# Can I mix first gen LS-5 and new LS-5V2

Clemens - 2022-04-20 - LS-5

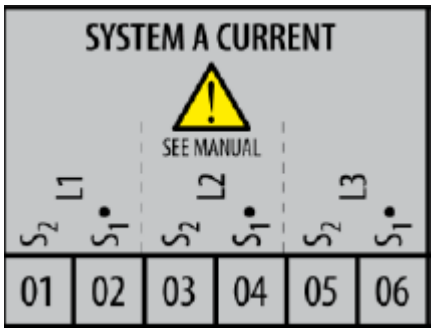
- Keep in mind that mains hardware difference between LS5 and LS5V2 are the current measurement terminals. In first generation LS5 there are 3 terminals for current sensing and a 4th common terminal.

In LS5-V2 each current input has 2 terminals for each current
